CCK-2729-24
UKHC Parking Structure #8 Expansion BP#01
Project# 2565.0
ADDENDUM #5
07/13/2023

#### **PARKING STRUCTURE 8 EXPANSION**

### **ITEM NO. 5.01**

MOCK UP 3D ISO

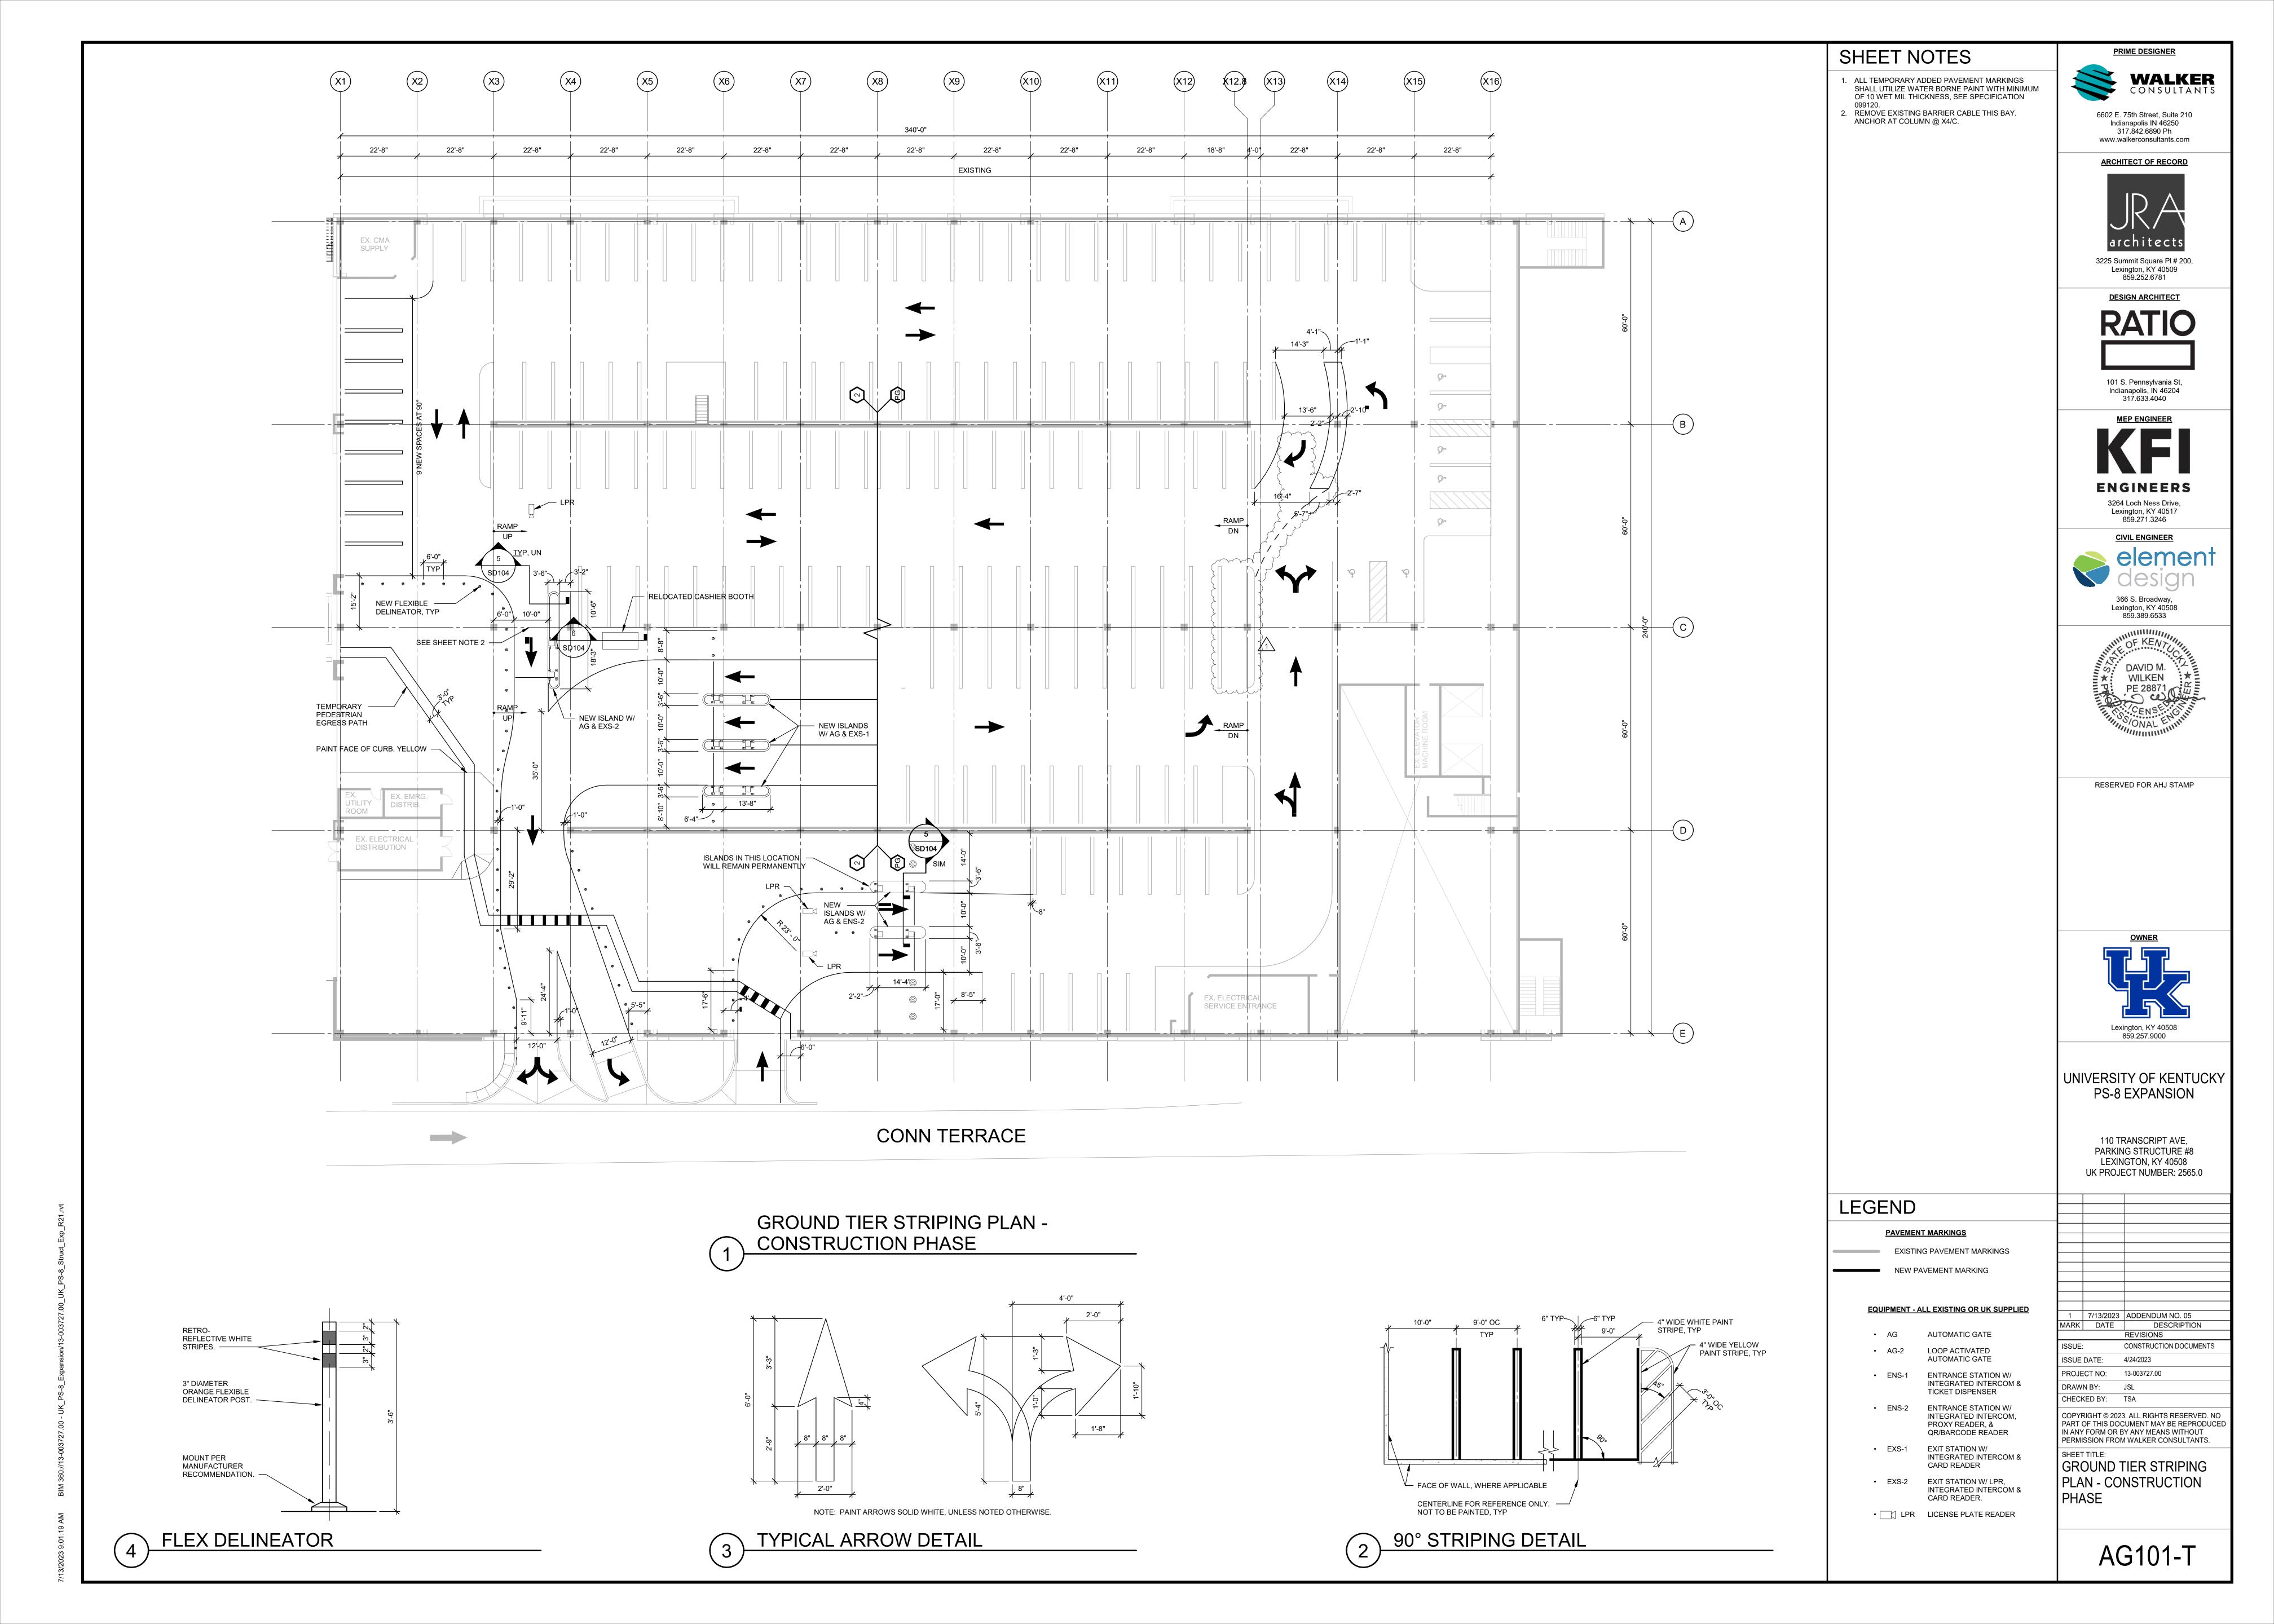
Refer to newly issued drawing sheet A-911. This sheet details the requirements for a mock-up panel. Refer to the site plan for location. This requirement supersedes the requirement for the panel mockup shown on drawing sheet A-212.

E-204A

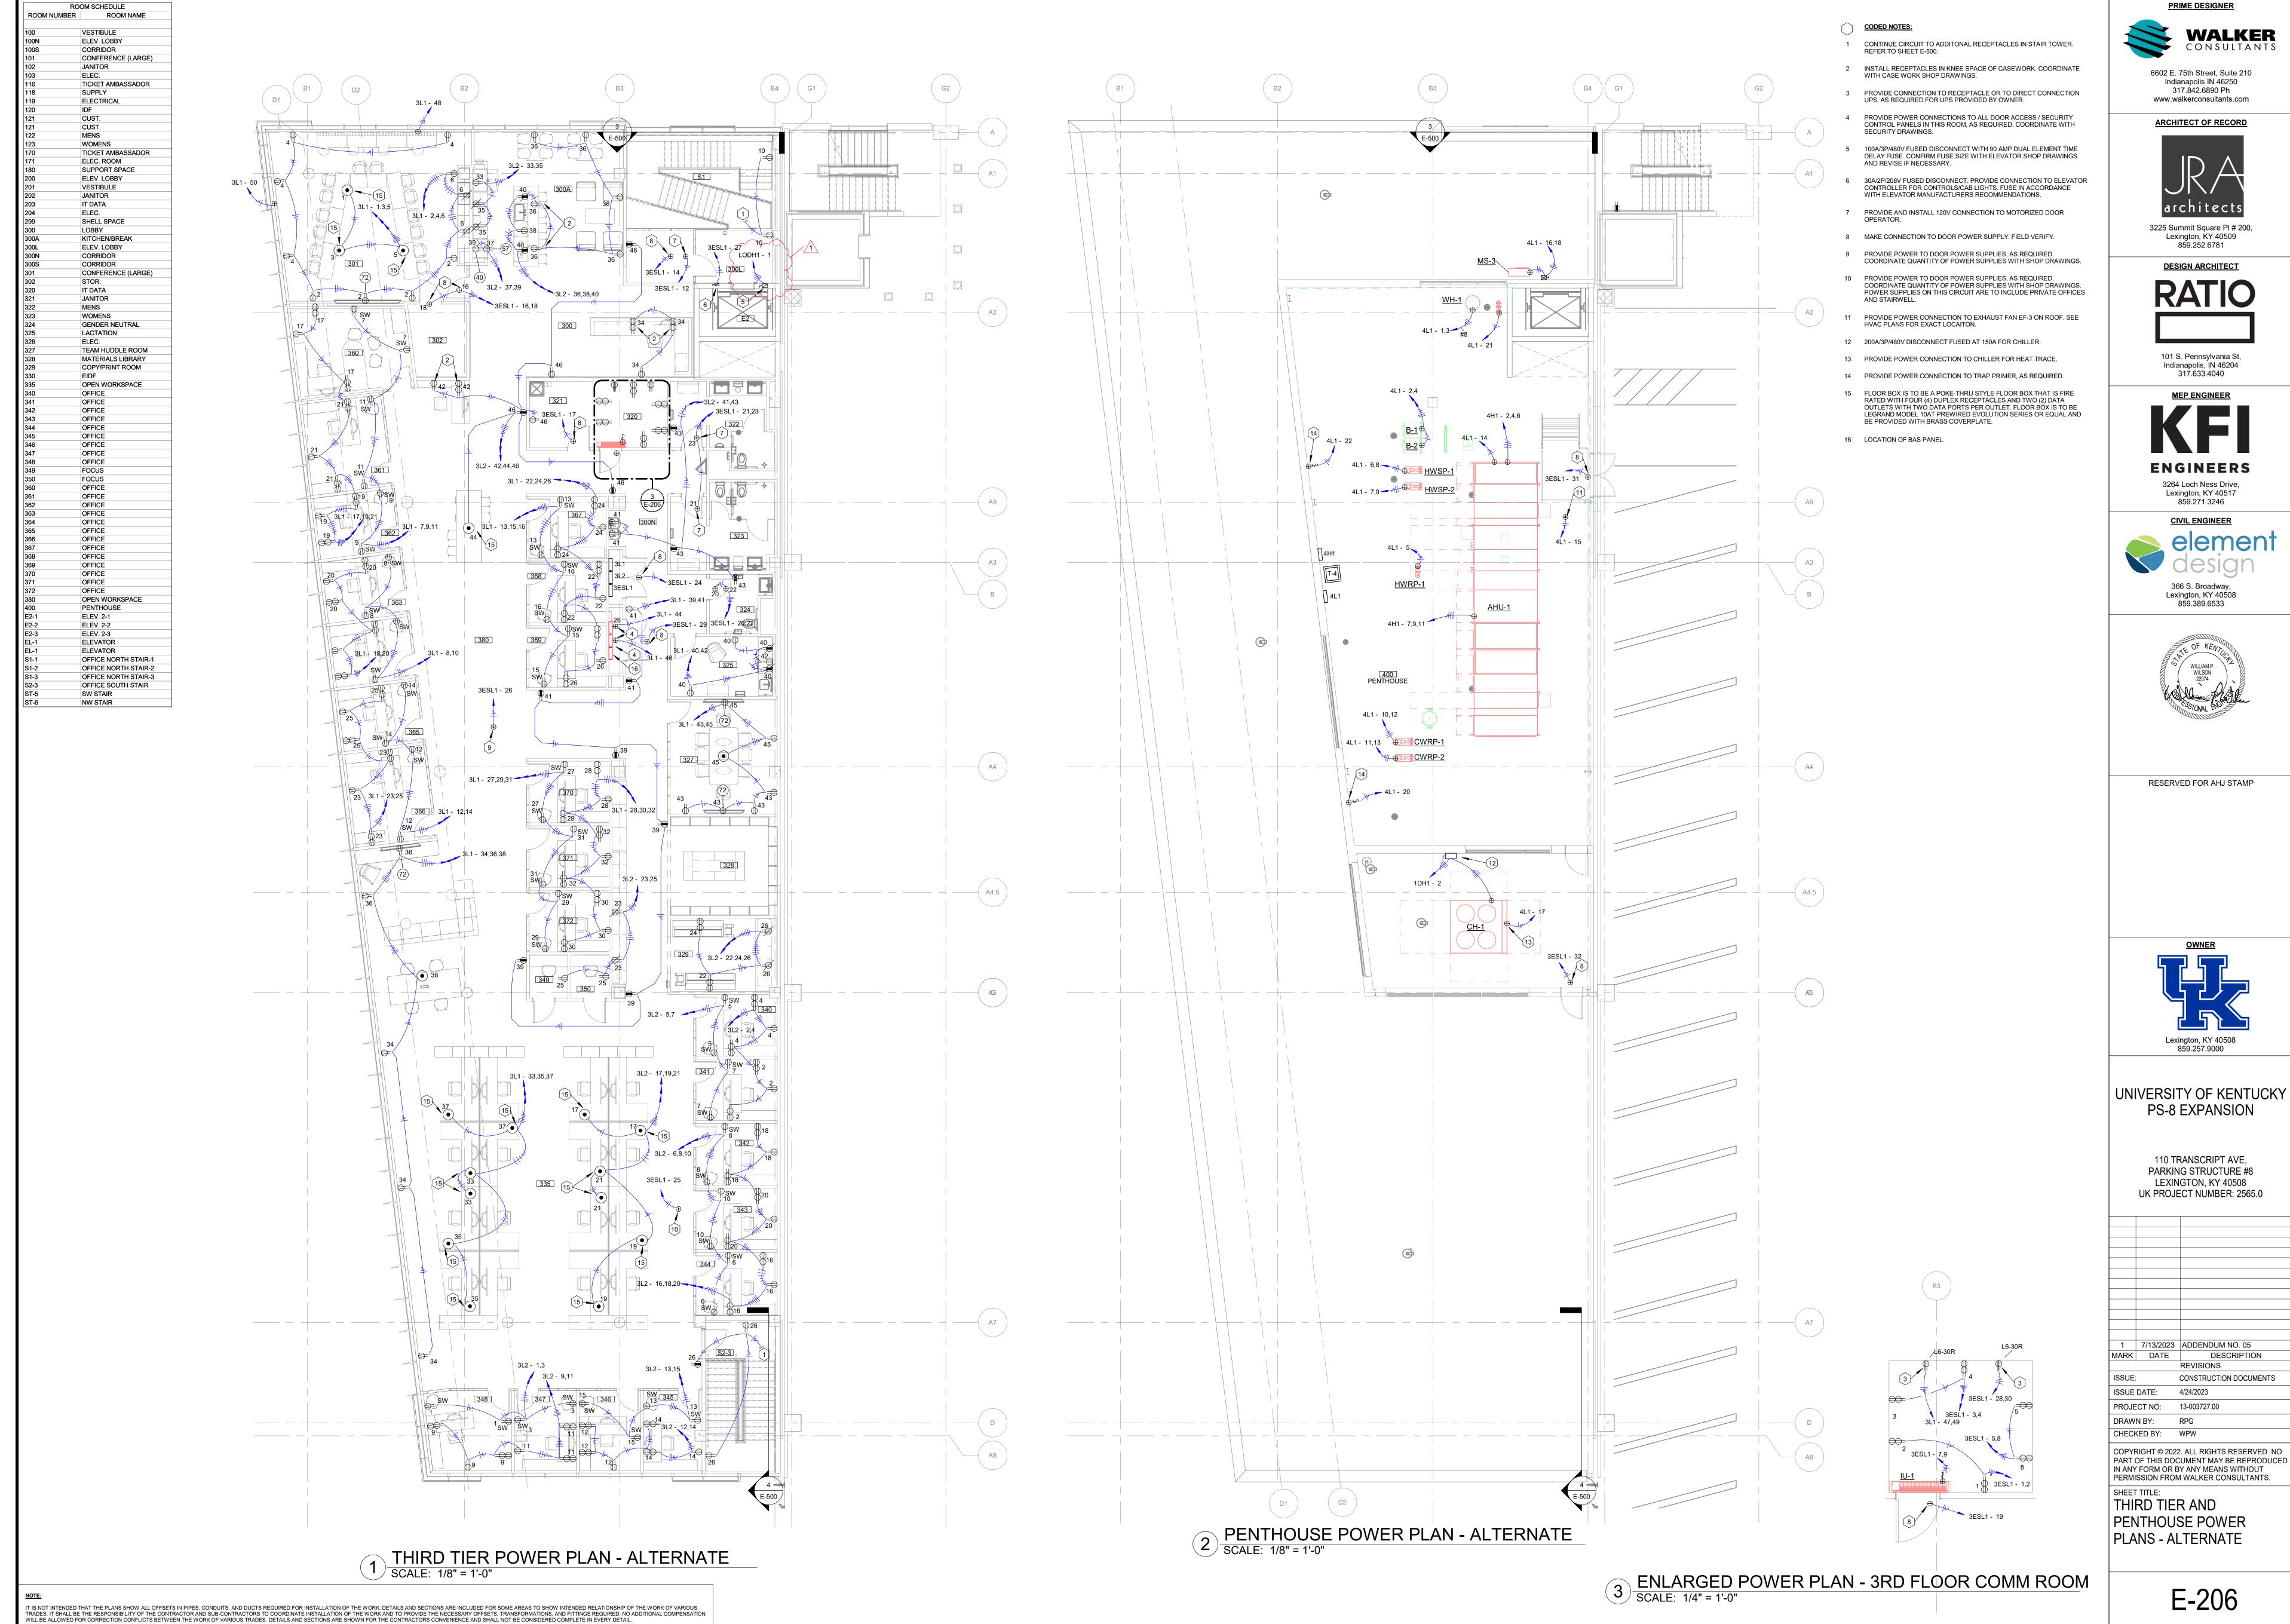
Refer to Sheet E-204A: Elevator circuit changed to existing panel LODH1.
